# REVISED HERITAGE IMPACT ASSESSMENT & CONSERVATION PLAN FOR 211-231 BANK

**Applications D02-02-22-0127 / D07-12-22-0188 and plan number 18910**

Revision 2: October 2024

The following conservation plan is an update of the HERITAGE IMPACT STATEMENT submitted June 2023, Applications D02-02-22-0127 / D07-12-22-0188 and plan number 18910. It responds to comments provided by the City of Ottawa. The comments are listed below:

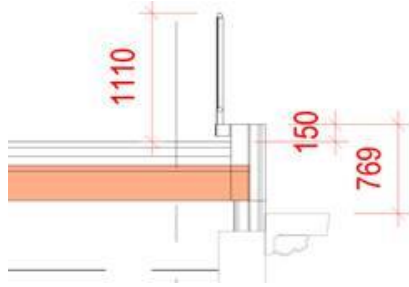
This could be a red/brown or black accent colour that relates to the existing brick or cornice colour. This will help to integrate the new construction better to the Centretown HCD.

- Remove or push back the wall/railing above the second storey building along Bank Street.

*The upper floors were intended to provide background vanilla and help focus on the podium and pedestrian scale of Bank Street. The planned Richcraft highrise towers adjacent to the site will overwhelm the nine storey and the distinction will further emphasis the foreground.*

*The height of the third level has been increased to maintain headroom. The bulkhead and railing have been set back, with the cornice standing proud of the façade. As illustrated by the image, the level (orange) is located above the cornice, we need to add a wall in this area anyway.*

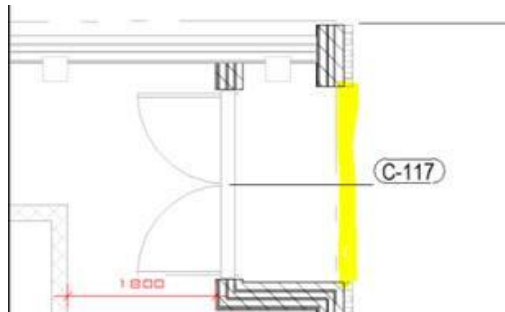
- Recess the Lisgar entrance to maintain the character of the carriageway. This feature was identified as a heritage attribute in the Conservation Plan and there are few left in the HCD, so should be respected.

*The doors have been set back but with the need for security and these alcoves being used for sleeping, would a metal grid used at night be acceptable (yellow highlight below)?*
